LASER INTERFEROMETER GRAVITATIONAL WAVE OBSERVATORY
- LIGO -
CALIFORNIA INSTITUTE OF TECHNOLOGY
MASSACHUSETTS INSTITUTE OF TECHNOLOGY

Technical Note	LIGO-T0900513-v1-0	Date: 10/19/2009
Electrostatic Drive Redesign Suggestions from LASTI Experience		
Brett Shapiro

Figure 1: The LASTI ITM CP ESD. The cable terminate at the 3 and 9 O'clock positions. Note the proximity of the structure at those points. Also visible is an improvised guide wire holding the cables together in the gap between the penultimate mass and reaction mass.

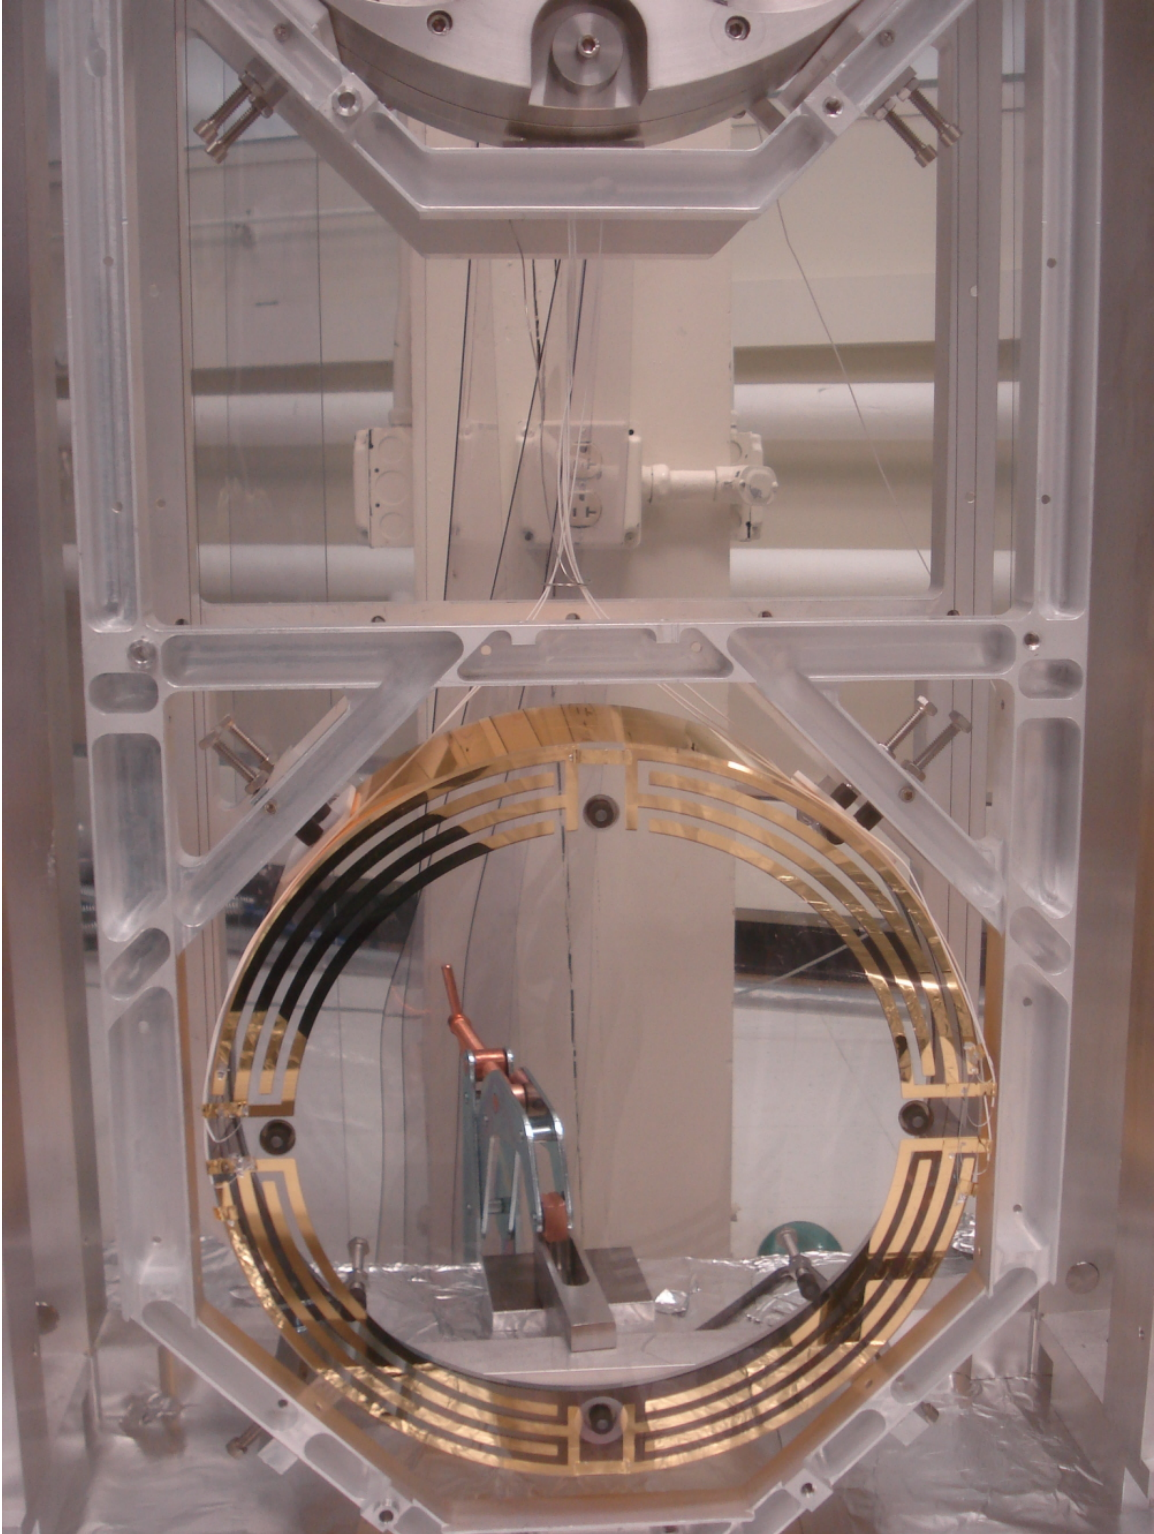
2. Improve the cable routing to tidy up the cables on the way down from the PUM.

The current configuration has the cables traveling out to the sides of the reaction mass (3 and 9 O'clock positions). Since there is no intermediate clamp between the penultimate mass and the end points of the cables, they tend to flare apart on the way down, which risks bumping into earthquake stops, the structure, or falling in the gap between the test and reaction masses. The controls prototype ESD avoided this issue by tacking the cables directly to the barrel with Vacseal. At LASTI we improvised a makeshift guide wire hanging off the bottom of the penultimate mass that holds the cables together until they reach the top of the reaction mass.

3. Improve the clearance of the cable termination points with respect to the structure.

The clearance is tightest right at the 3 and 9 O'clock points. Most of this issue is already solved by item 2 above. However, if the lower channels cannot be routed to the top of the reaction mass shifting the lower connections down below the 3 and 9 O'clock points will improve the clearance. The cables will still need to hug close to the barrel on the way up or they will run into the same clearance issue with the structure.

A suggestion to fix this issue is to move the cable connections to the top of the reaction mass. The top of the reaction mass is less accessible to the two bottom control channels, thus only 3 of the 5 cables make it easily to the top. One possible solution is to run the two lower cables up the barrel and tack them down somehow on the barrel near the top. Another is to create an isolated trace in the existing gold barrel coating of the compensation plate. Experience at LAST did show the lack of robustness in the barrel coating. It rubs off extremely easily (the LASTI CP has smudge marks simply from handling), consequently this point should seriously be considered while designing the route of these lower channels. The gold pattern itself is much more robust since it is deposited on something other than glass, perhaps nickel.

The issue of falling in the gap can be further minimized by shifting the electrical connection of the cable onto the barrel. A previous proposal suggests folding a tab or the gold pattern itself over the bevel onto the barrel. Another suggestion I heard proposed was to attach a connector onto the center of the barrel's top surface, where the cables from above would terminate. Obvious considerations relate to the mechanical robustness of such a connector. For the compensation plate it might be prudent to leave a hole in the mechanically unreliable gold barrel coating where the connector will sit.
